Australian Government
National Capital Authority

Consultation Report

Works Approval No.s 101113 and 101127

Demolition of Existing Carpark and Construction of a
Mixed Use Residential Development

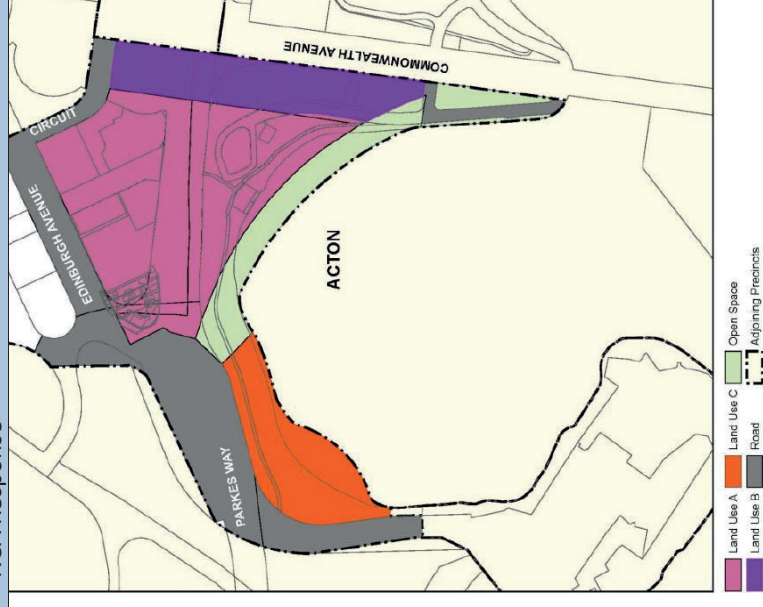
5.1	Setback of proposed building from Edinburgh Avenue Objection:	The terms of sale of the site were set by the ACT Government and include a range of off-site works. A deed of sale, administered by the Planning

Submission	Comment/Issue	NCA Response
	The proposed verge on the northern side of the extension of Edinburgh Ave from London Circuit to Vernon Circle is significantly narrower than the verges on the existing Edinburgh Avenue, west of London Circuit. This is unacceptable because: i. the set back of the proposed building is inconsistent with the principles of Walter Burley Griffin's original plans for the City Hill precinct and inconsistent with the NCA's Amendment 56 <i>The Griffin Legacy Principles and Policies</i> ii. the set back of the proposed building will only allow a single row of tree plantings along the northern side of Edinburgh Avenue. This is inconsistent with the double row of trees on the northern side of Edinburgh Avenue, west of London Circuit. iii. the set back of the proposed building encroaches onto Edinburgh Avenue in a manner inconsistent with other structures along the northern side of Edinburgh Avenue, obstructing the 'view corridor' along the key axis from City Hill Width of verge from proposed building to Edinburgh Avenue: I cannot locate plans showing the distance of the proposed building from Edinburgh Avenue in the available information. It is apparent from diagrams that the verge between the proposed building and Edinburgh Avenue is significantly narrower than the north and south verges on Edinburgh Avenue west of London Circuit, as the applicant acknowledges: <i>The existing landscape features of Edinburgh Avenue, west of London Circuit, include a wide verge on the northern and southern sides of the street with paved connecting pathways, grassing, understorey planting and tree planting.</i> <i>The northern verge includes pathway access provided along the back of kerb (adjacent the parking bays), a secondary pathway adjacent consolidated garden bed planting and main pathway along the building line / property boundary.</i> <i>Soft landscape features on the northern verge consists of a double row of Eucalyptus mannifera under planted with Poa species. A row of Platanus species in grass exists to the south of the main pathway. The southern verge includes mature Eucalyptus mannifera species and grassing.</i>	Directorate, ensures the property owner meets these obligations to deliver off site works. The Edinburgh Avenue extension aims to create a new public realm, responding to and consistent with the existing City Hill design and recently completed Constitution Avenue extension. Part 4.5.6 <i>City Hill Precinct</i> of the National Capital Plan (NCP) states: <i>Landscape and streetscape treatments are to be of a high quality emphasising the geometry and formality of the Main Avenues.</i> <i>New road connections to Vernon Circle from Constitution and Edinburgh Avenues should facilitate access for local traffic and pedestrians. View corridors must be retained from radiating avenues to City Hill Park. No buildings should bridge these avenues.</i> <i>A limited palette of high-quality pedestrian pavement materials, street furniture and lighting will be used. Pavement and landscape design should have an elegant, simple and bold design emphasising the geometry and formality of the main avenues.</i> The proposed development maintains and enhances existing avenue connections and public domain vistas along roadways. No buildings bridge Edinburgh Avenue. The proposed development includes high quality materials and finishes for the pedestrian environment. The indicative typical cross sections for Avenue Extensions shown in the National Capital Plan prescribe a width of 40m. The proposal is consistent with the prescribed width outlined in the NCP. The Edinburgh Avenue extension creates a new public realm with a shared path, large canopy trees and understorey planting on both the northern and southern verges. Due to the variable width of the shared path (from 6.4m to 3.2m) and the inclusion of seating adjacent to the garden beds only one row of street trees can be accommodated. The verge street trees are

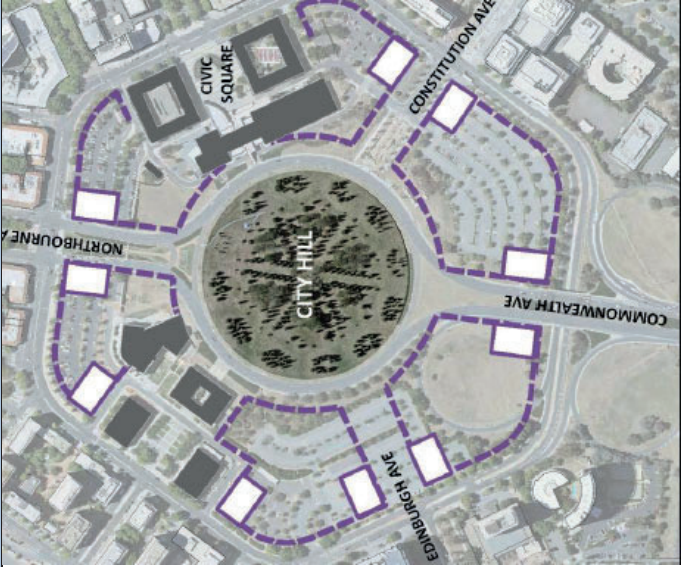
1. Stage 1 works as outlined will remove passive solar access to my residence
2. Parameters of works during the construction phase of the development

The proposal as outlined for Stage 1, facing onto Vernon Circle, is too high and will deny solar access to my residence. At present the tallest building facing onto Vernon Circle is the new Supreme Court building, this height will allow for

The proposal meets the objectives of the City Hill Precinct outlined in Part 4.6.3 of the National Capital Plan (NCP).

The proposed development will frame the vistas to City Hill Park when viewed from adjacent main avenues. The NCP allows for building heights of up to 25 metres (generally six to eight storeys) above adjacent kerb levels of London Circuit, Vernon Circle and Northbourne, Edinburgh, Constitution and Commonwealth Avenues in all areas of City Hill Precinct.

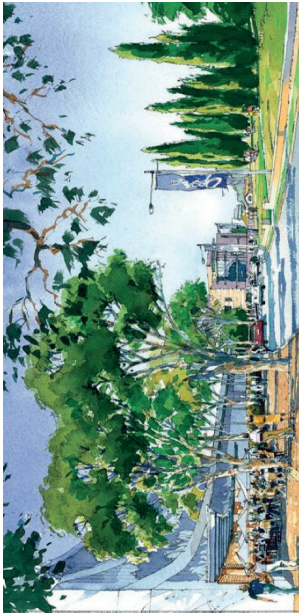
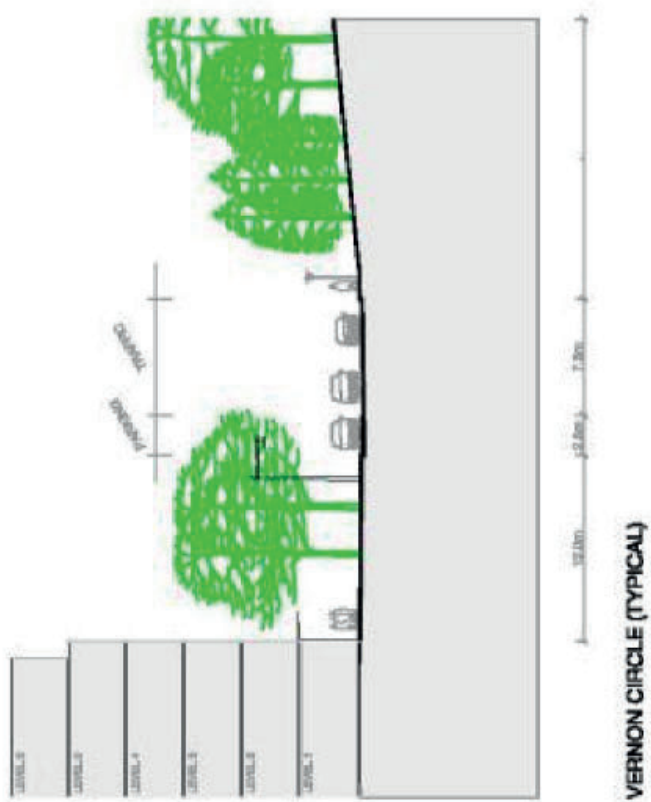
Submission	Comment/Issue	NCA Response
9.	Ms Roby Coghlan	
9.1	This proposal adopts the usual practice of developers in maximising the number of dwellings at the expense of the environment. The entire land surface will need to be cleared of all trees and other vegetation. Buildings will extend from the limits of the blocks with no setbacks from the footpath and road. The area will replicate the existing developments on the other side of London Circuit where internal roads are narrow and set in small canyons. This might suit cities where sunshine is not important in winter and where daily temperature extremes are not as great as in Canberra but it is a retrograde step for Canberra. The central area for the recreational purposes of residents in the current proposal is set on the podium, which is on Level 2 above ground level. This means there will be no grass and no deep-rooted trees or other plantings. This will exacerbate the heat-island effect of the buildings in summer and will contribute to global warming. This narrow open space is closed at the northern end and open at the southern end, which minimises the amount of sunshine that will penetrate in winter, given the area will be surrounded by six storeys on north, east and west. Solar access to units will not meet the standards.	Podium landscape works are subject to a future works approval application. The NCA will ensure that all species selected, including trees, are suitable to the site conditions and scale of development, and have the ability to grow to full maturity.

Landmark buildings up to RL617 (generally 14 to 18 storeys) will be restricted to the locations identified in Figure 40 (below), generally being the corners of the main avenues intersecting with London Circuit.

The proposal is consistent with Part 4.6.5 *Detailed conditions of planning, design and development* for the City Hill Precinct of the NCP.

The building that forms part of the Stage 1 development fronting Vernon Circle is 8 storeys in height, consistent with the provisions of the NCP. The building is set back 4.35m from the Vernon Circle block boundary which creates a sense of enclosure around City Hill Park, consistent with the primary building alignment/indicative development outlined in Figure 40 of the NCP. Buildings fronting London Circuit (future stages of development) are subject to a future works approval application.
